Pennsy Service Bulletin

Hinge Base Plate Crack

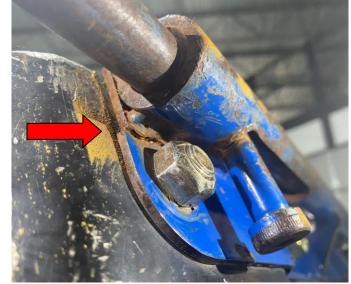
During routine service a crack in the base plate of the hinge may appear. This crack may go unnoticed during standard inspections.

- 1. During standard inspections, look for cracks near the weld affixing the hinge barrel.
- 2. Looking from the side of the bridge plate, observe the edge of the hinge base plate.
- 3. The crack will cause a portion of the hinge base to separate from the aluminum bridge plate.

- 4. Examine both the stationary-pin and sliding-pin ends of hinge.
- 5. Imperfections in the weld and damaged paint may visually present as a crack, verify presence of a crack using a pry bar and looking for movement of the crack.

If a crack is present and there is clear separation of the hinge base plate, remove the bridge plate from service and contact Pennsy Corporation. Bridge plate hinges showing no cracks pose no risk of failure and may remain in service.
